**SUBJECT:** Authorize City Manager to Sign Change Order No. 5 with Pyramid Construction and Aggregate, Inc. in the amount of \$59,250.00 for Cesar Chavez Blvd. Improvements Federal-Aid Project No. HPLUL-5168(017).

**CITY OF CALEXICO  
PUBLIC WORKS DEPARTMENT  
CHANGE ORDER NO. 5**

Name of Project: Cesar Chavez Blvd. Improvements  
Federal-Aid Project No. HPLUL-5168(017)  
Name of Contractor: Pyramid Construction and Aggregate, Inc.  
Date: 02/20/19

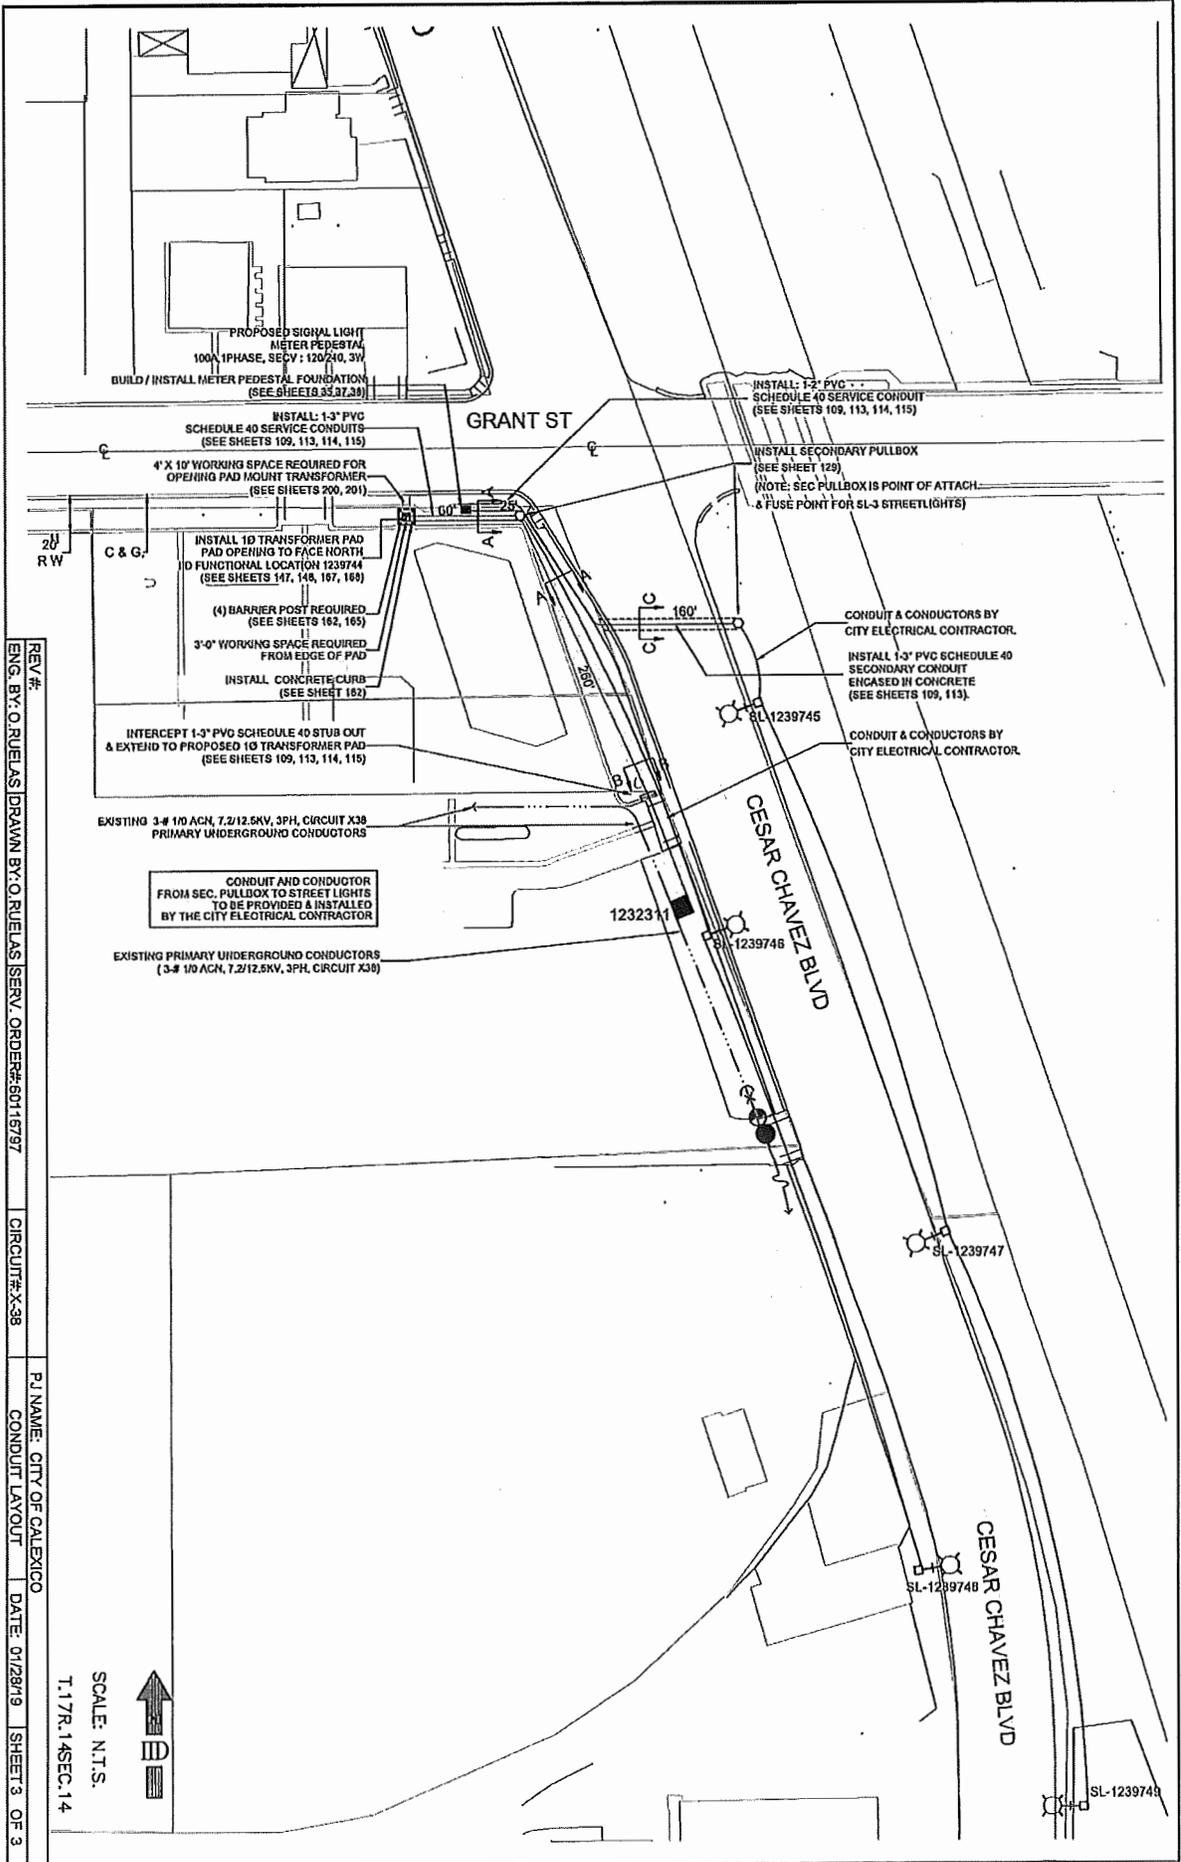
Pyramid proposes the following change order due to the IID requirements for electricity supplied for New Signal Lights and New Street Lights per IID's work orders:

New Transformer Pad and new meter pedestal pad per IID Work Order for Traffic Signal Lights at Grant and Cesar. Provide and install conduit, trench, backfill per IID requirements and IID inspections.

Compaction testing at transformer pad bollard's as per IID Drawings  
Surveying included.

Repair existing concrete due to damage during installation of lines.

CONDUIT LAYOUT

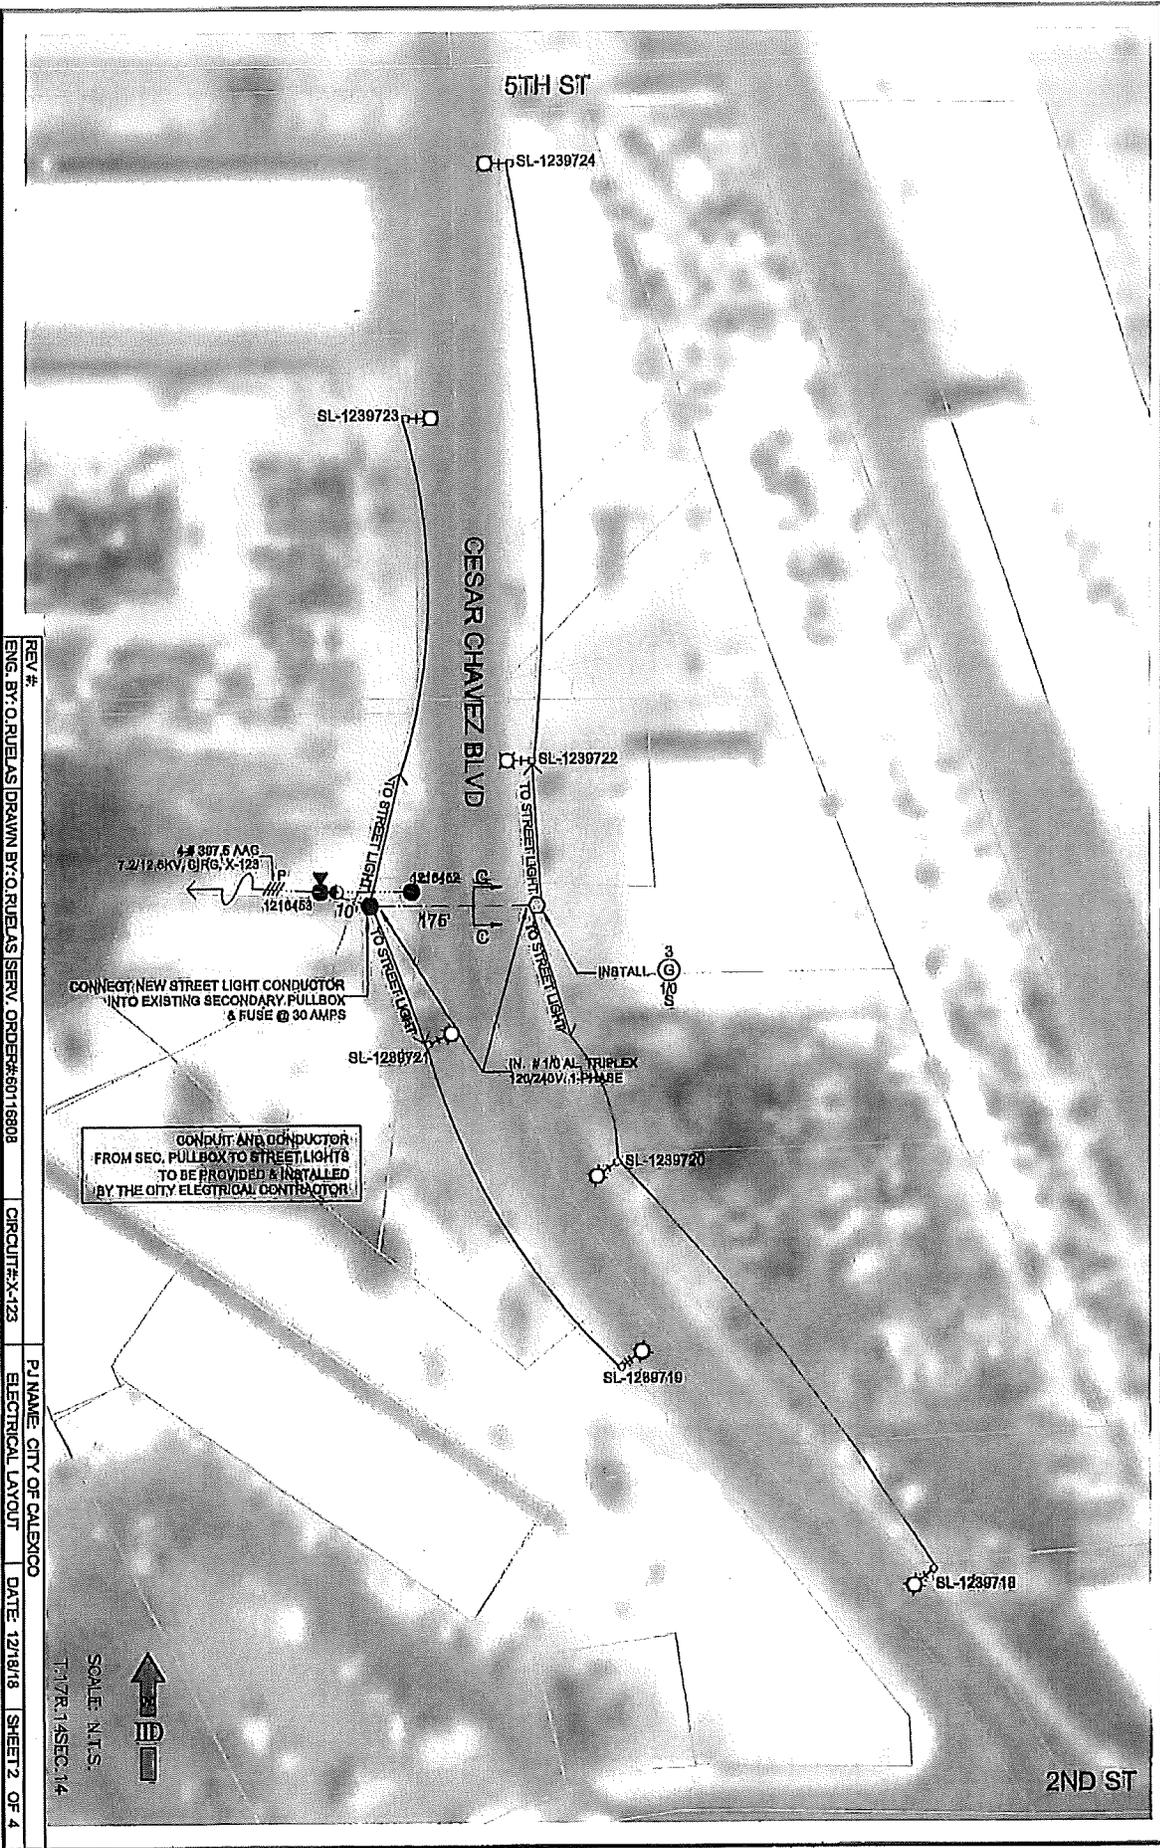
Provide and install pull boxes, conduit, trench, backfill from road to the IID power source at three locations along Cesar per IID work order for Street Light.

Compaction testing for conduit trench as per IID requirements.
